INDESIT company

Model type:
AT104EX

Commercial code:
F028074

# Notices

## n1040245: Brembate washing machine basket doors re

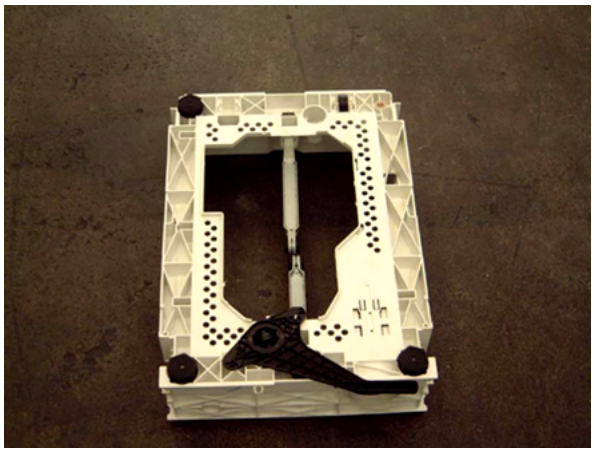
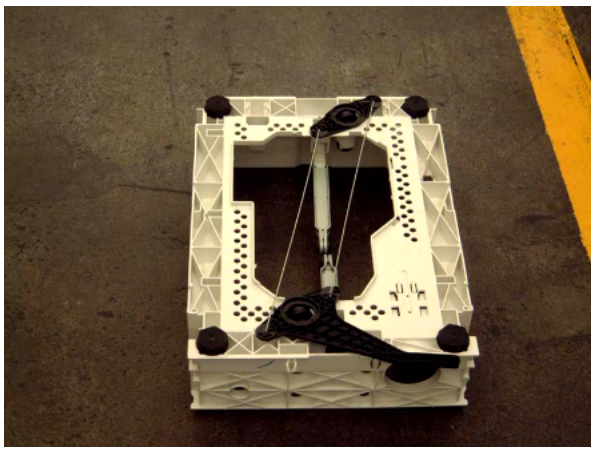
For all washing machine models produced in the Brembate factory and relevant to this note, in replacing the loading mouth code 083895/112743/252375 proceed as follows:
-remove the 18 rivets (9 on the right, 9 on the left) hooking the two doors to the loading mouth on the machine;
-take replacement part 083895/112743/252375 and carry out the same operation described in the previous point;
-hook the two new doors and the new loading mouth on the basket of the machine using the nut and bolts kit code 080691 (formed of 18 screws + 18 washers + 18 nuts);
-use silicone (SAT code 081629) for hooking the loading mouth on the basket.

## n1040288: Power supply cable + moulded filter on top-load Brembate WMs

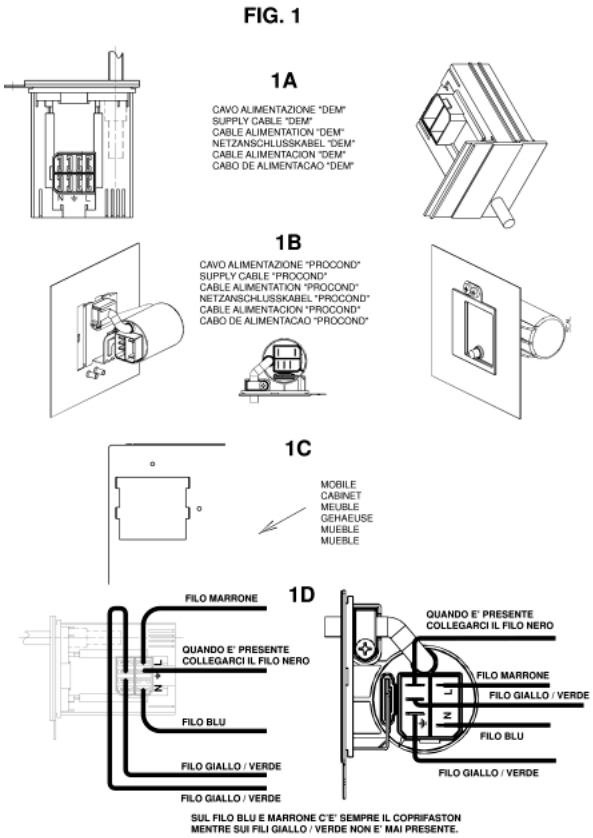
From serial number 30224.0001, all top-load washing machines produced in the Brembate factory have been equipped with a new power supply cable with moulded filter and new rear panels with a specific opening for fixing the new cable.

The new power supply cables are:
Sat code 091632 Power supply cable 3x1 schuko 1.5m+capacitance filter;
Sat code 091633 Power supply cable 3x1 schuko 1.5m+inductive filter;
Sat code 091641 Power supply cable l=2550mm ag +capacitance filter;
Sat code 091635 Power supply cable uk 3x1 l=1950mm+capacitance filter;
Sat code 091634 Power supply cable uk 3x1 l= 1950mm + inductive filter;
Sat code 091689 Power supply cable l=2550mm ag +inductive filter.

The new rear panels are:
Sat code 094067 - premodification Sat code 091893 (used for few months in place of code 083784, see N1040278);
Sat code 094068 - premodification Sat code 093623 (specific for the Hotpoint WMTL80UK model, commercial code 28749).

To use premodified wirings on modified products perform the connection to the terminal block of the new cable as shown in fig. 1 - 1D.
The wiring diagrams indicated in the Documentation remain the same.

N1040309FIG1

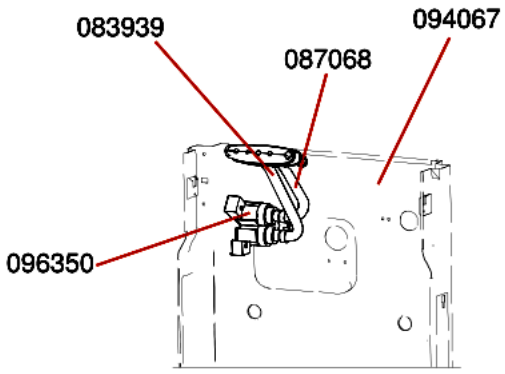
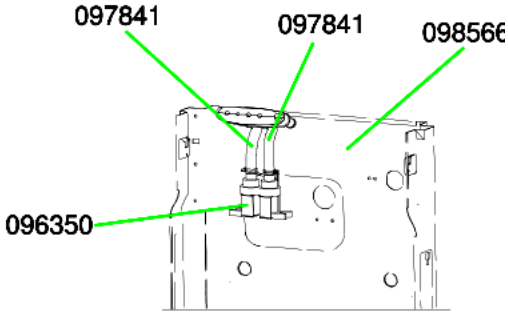
From serial no. 30912.0001, the system used for fixing the loading solenoid valve (spare part code 096350) to the rear panel has been modified on Top Loading washing machines, rotating its position by 90°.
The solenoid valve (spare part code 096350) has been modified with the 45° rotation of a coil; the Replacements Warehouse will continue to manage this part with the same code. When replacing on premodification machines, fit the coils as shown in figure N1040309FIG3-1 and on modified machines, as shown in figure N1040309FIG3-2; to rotate the coil, lift it using a screwdriver and then refit according to the inserts on the plastic.

Replacement codes of the parts affected by this modification (see figure N1040309FIG1):

FIG1 A - PREMODIFICATION STRUCTURE
solenoid valve tube/distributor assembly: premodification 083939;
solenoid valve tube/distributor assembly: premodification 087068;
rear panel: premodification 094067.
FIG1 B - NEW STRUCTURE
solenoid valve tube/distributor assembly: new 097841;
solenoid valve tube/distributor assembly: new 097841;
rear panel: new 098566.

N1040309FIG2

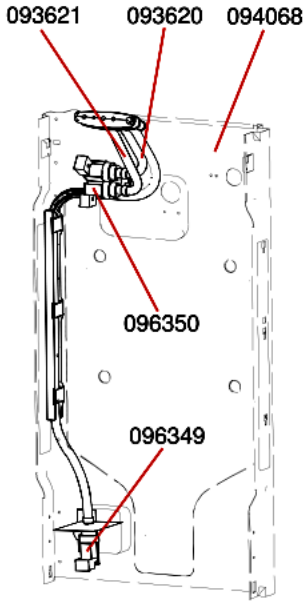
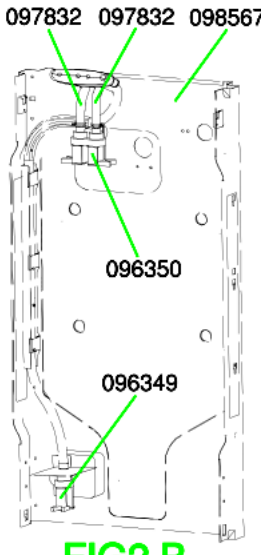
Replacement codes of the parts affected by the modification to WMTL80UK (see figure N1040309FIG2):

FIG2 A - PREMODIFICATION STRUCTURE
solenoid valve tube/distributor assembly: premodification 093620;
solenoid valve tube/distributor assembly: premodification 093621;
rear panel: premodification 094068.
FIG2 B - NEW STRUCTURE
solenoid valve tube/distributor assembly: new 097832;
solenoid valve tube/distributor assembly: new 097832;
rear panel: new 098567.

N1040309FIG3

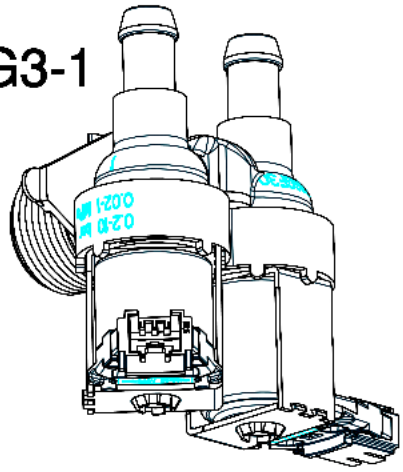
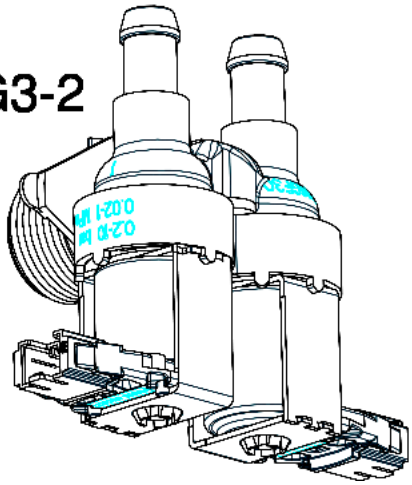
Premodification panels will be managed by the Replacements Warehouse while stocks last; when replacing with new ones on premodification appliances the new tubes must also also be used.
When using the new panels on appliances before serial no. 30609.0001, fitted with solenoid valve code 083940, rotate the coil 45° and follow the instructions given above for code 096350, paying attention during the wiring phase to keep the cables away from the bowl support spring.

n1040321: Plastic protecion for solenoid valve.

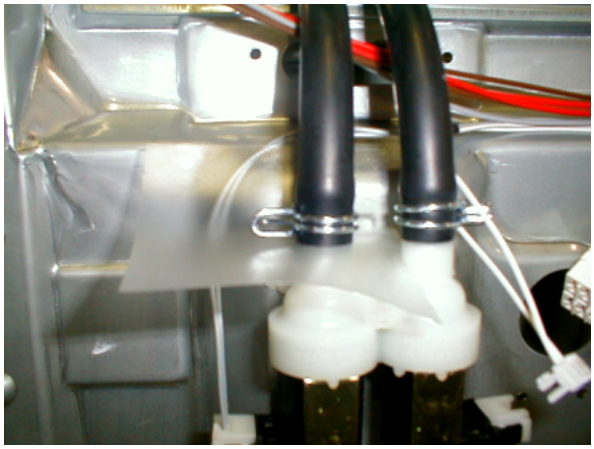
All top-load washing machines produced from September 2003 to February 2004 (from serial no. 30900.0000 to 40300.0000)

have been equipped with a plastic protection Service code 109798 (shown in N1040321FIG1), to prevent water from damaging the solenoid valve and electronic card.

N1040324FIG1

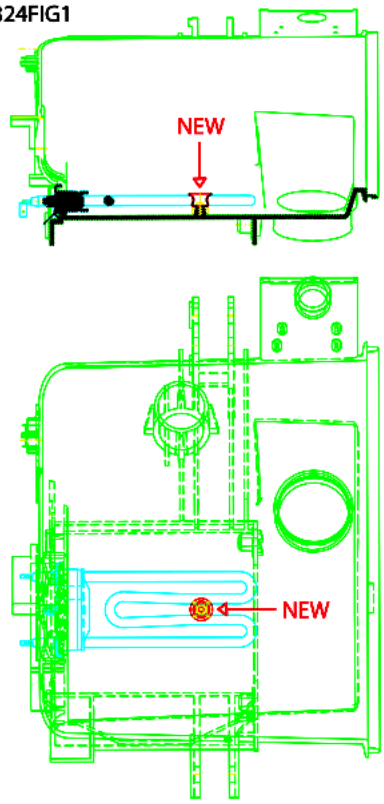
From serial number 40506.0001, the fixing system of the heater to the tank has been modified on all top-load washing machines affected by this note, with the introduction of a metal retainer (image N1040322FIG1 reference NEW) in place of deflector Service code 055322.

The modification has involved both heater and tanks. Given below are the Service codes of the new and old items concerned:

-PLASTIC TANK FOR 600-1000 RPM MACHINES: new 110152, premodification 083805;

-PLASTIC TANK FOR 1200 RPM MACHINES: new 110153, premodification 092023;

-HEATER: new 110148, premodification 083906.
